ADDENDUM NO. 2

PROJECT: Indiana School for the Deaf, Building 8 HVAC Renovation
DAPW PROJECT NO: 49026008-20-040
R&B PROJECT NO: 2148-02
DATE: 10/26/2022

Indiana School for the Deaf, Building #8 HVAC Renovation

1 ENLARGED TYPICAL MECHANICAL PENTHOUSE PLAN - AHU-1, 2, 7, 8
1/4" = 1'-0"

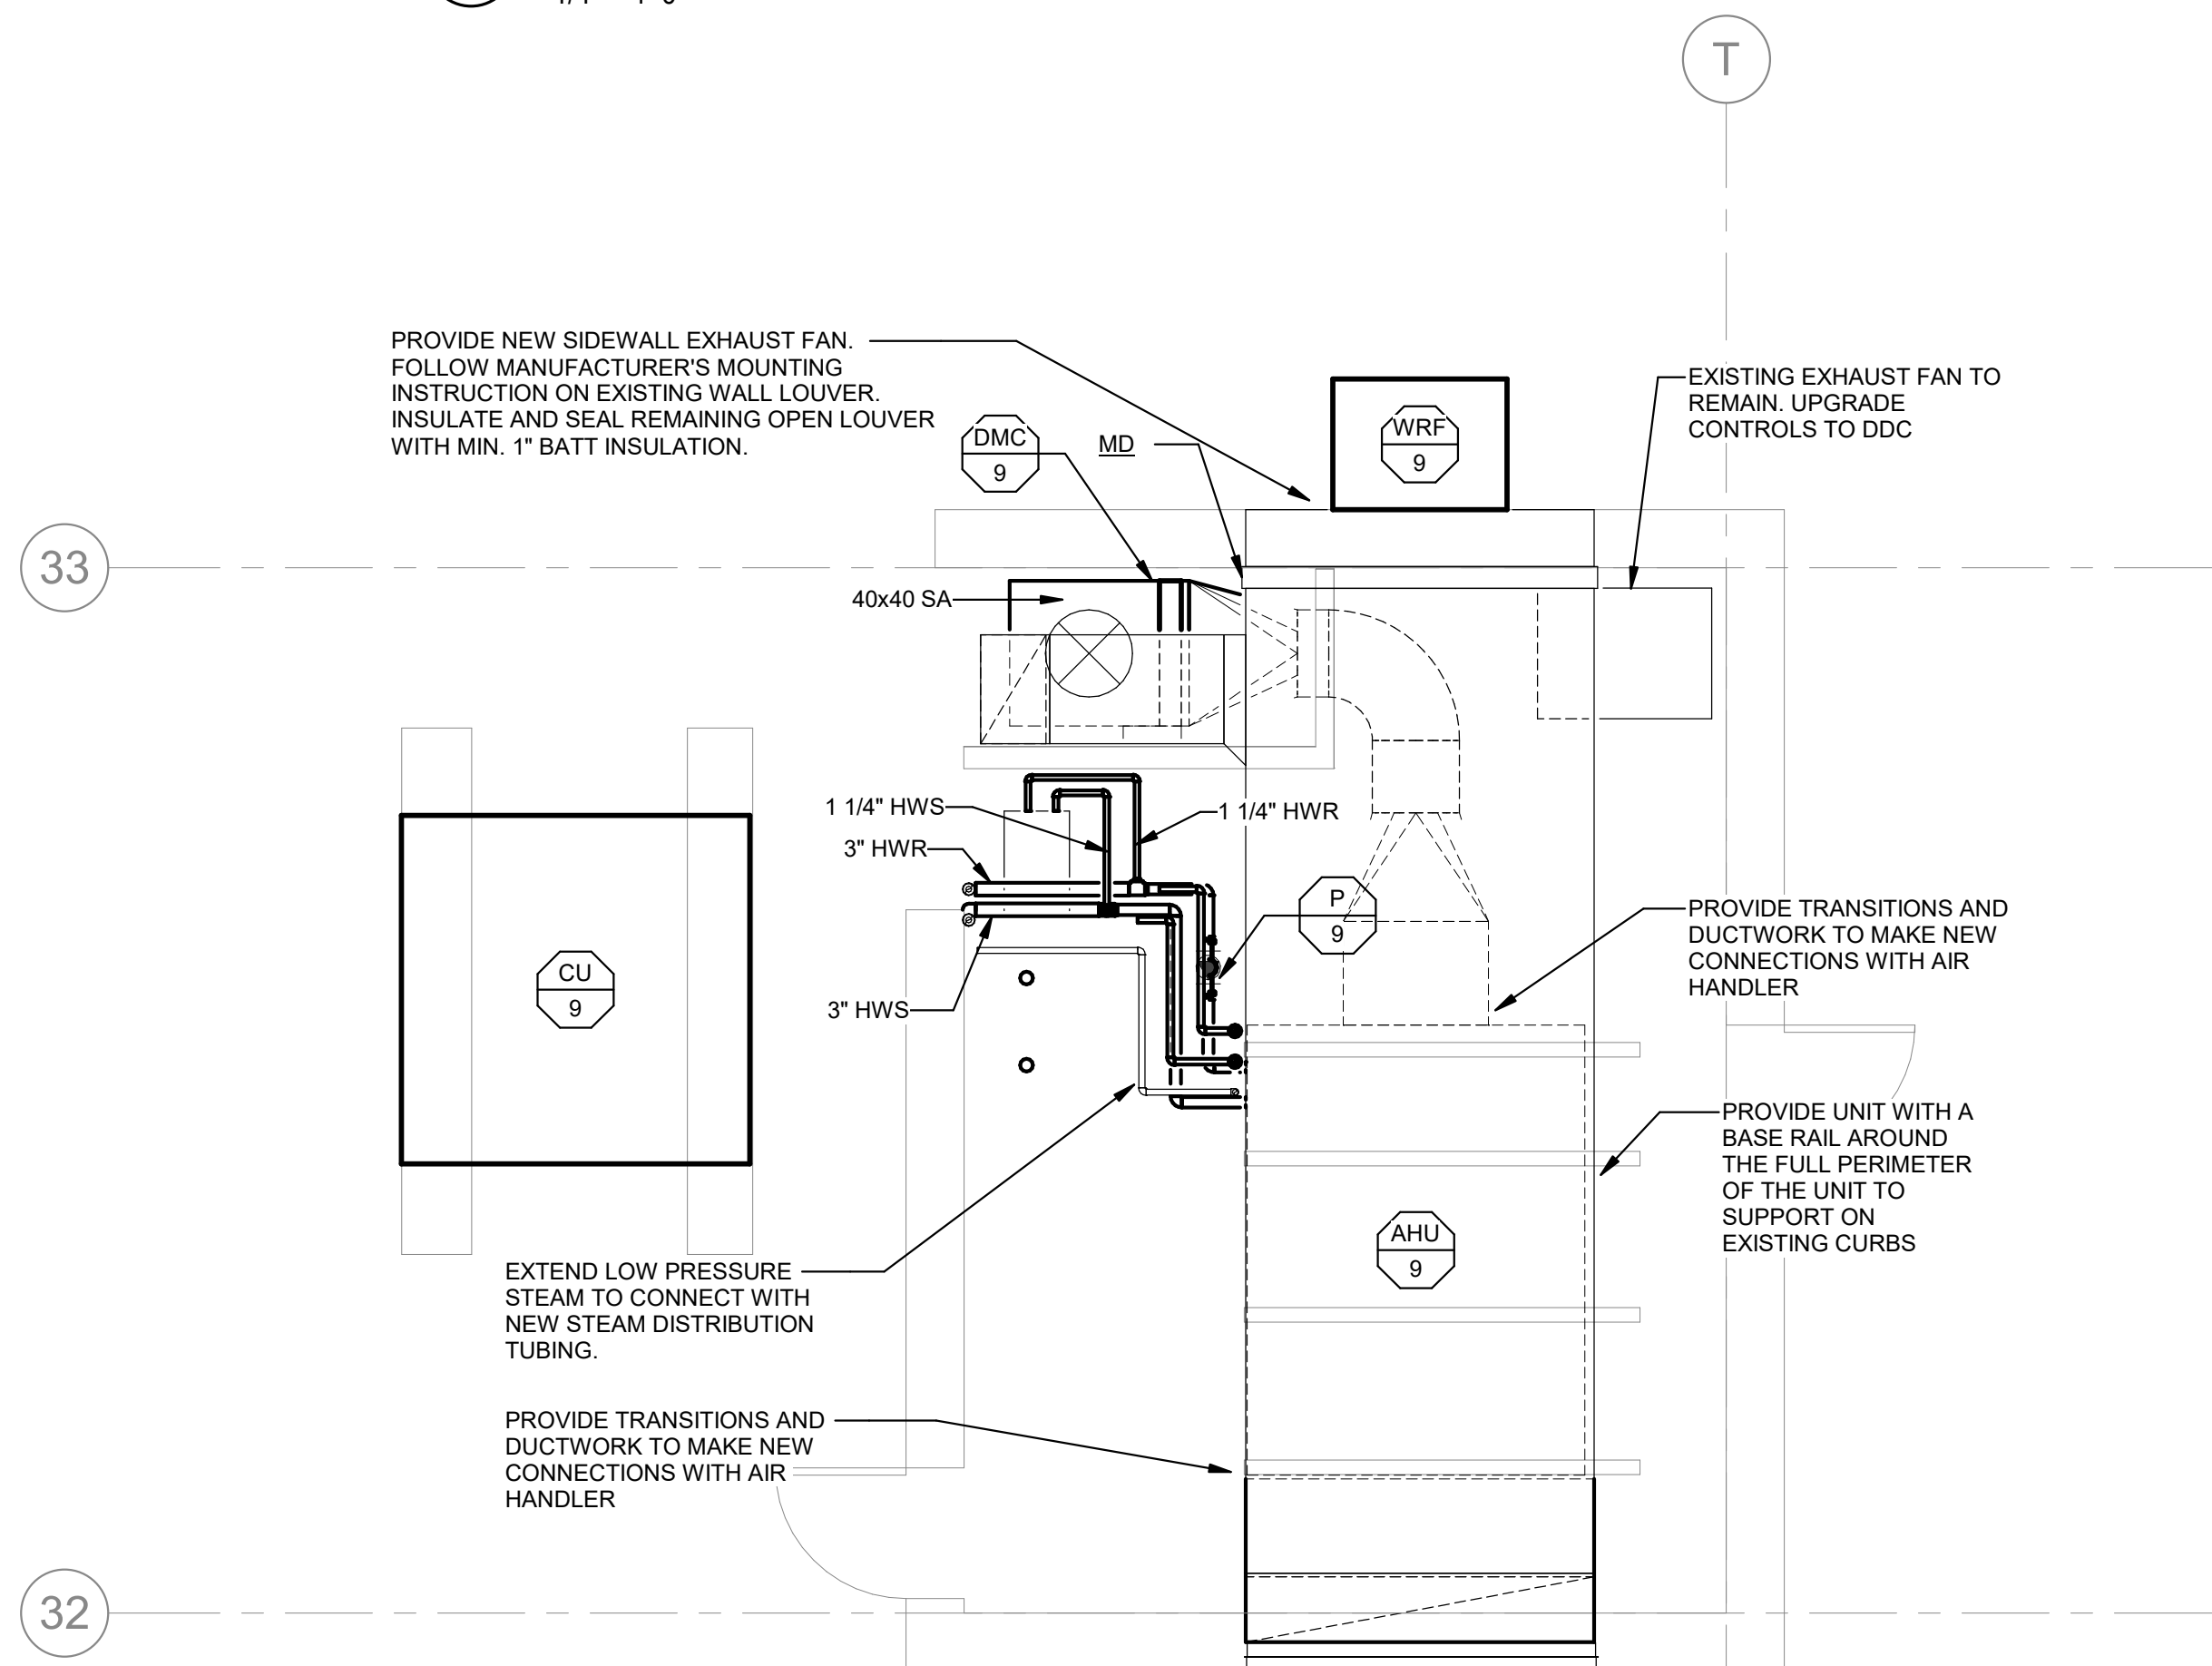
1. Cover Sheet:
 - a. Updated alternate #1 to add CSAC-6 scope for the installation of DMC-6.
2. MD114B:
 - a. Added additional demo scope for CSAC-6 for alternate #1 to be able to install DMC-6.
3. M201:
 - a. Added DMC-6 to the SA ductwork from CSAC-6 for alternate #1
4. M601:
 - a. Added the Duct Mounted Coil Schedule.
